PAWTUCKET HOUSING AUTHORITY REQUEST FOR BIDS

PAWTUCKET HOUSING AUTHORITY GALEGO COURT RECLAMATION AND RESURFACING PROJECT

ADDENDUM No. 2 September 6, 2022

DRAWING TITLE: **GENERAL NOTES and**

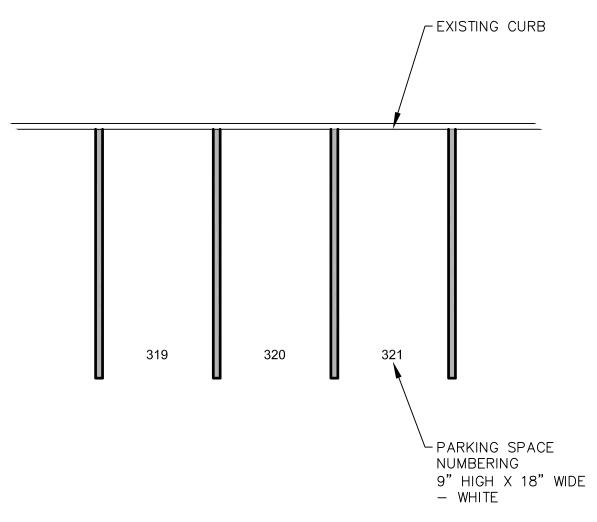
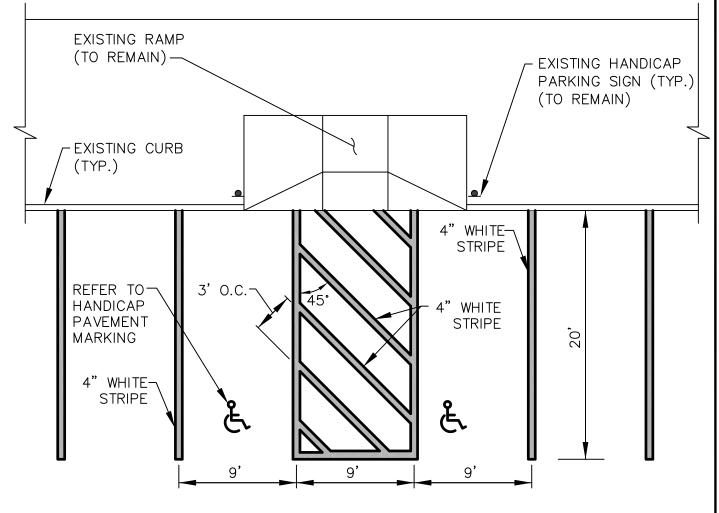
1. <u>Delete</u> GENERAL NOTES AND LEGEND NO. 1, Sheet 2 of 10 in its entirety and <u>insert</u> revised GENERAL NOTES AND LEGEND NO. 1, Sheet 2 of 10, attached to this Addendum No. 2.

Striping note no. 2 has been revised to reference waterborne paint.

1. All proposed pavement markings shall be waterborne paint. Epoxy resin pavement markings have been deleted from the project.

TYPICAL CROSSWALK PAVEMENT MARKING DETAIL

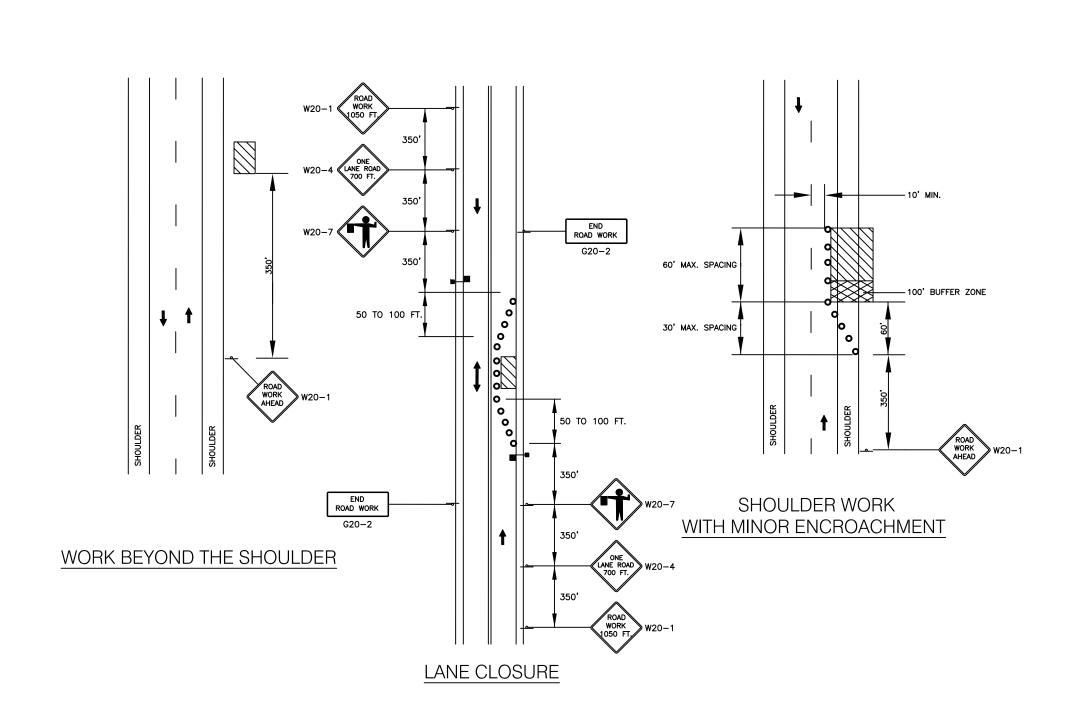
The Typical "NO PARKING" Pavement Markings note has been revised to reference waterborne paint. The Typical Crosswalk Pavement Marking Detail has been revised to reference waterborne paint.
